BCA 2022 SECTION J INDICATIVE COMPLIANCE REPORT FOR DA LODGEMENT

**69-73 George Street,
Marulan NSW 2579**

Prepared for: Dacoas Holdings Pty Ltd
Project No.: PRO-08737-K8D0
Date: 21/12/2023
Status: Report Issue v1.0

NCC 2019 J1.5 Façade Calculator (Valid for NCC 2022 Clause J4D6) – Report

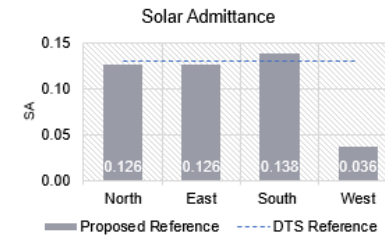
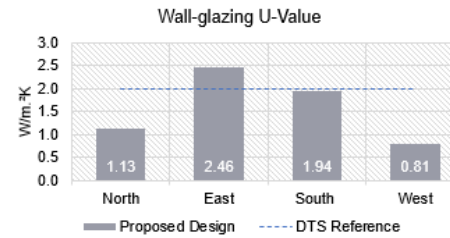
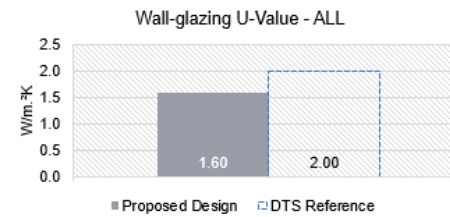
Method 1				Method 2
	North	East	South	West	All
Wall-glazing U-Value (W/m².K)	1.13	2.46	1.94	0.81	1.60
Solar Admittance	0.13	0.13	0.14	0.04	
AC Energy Value					71
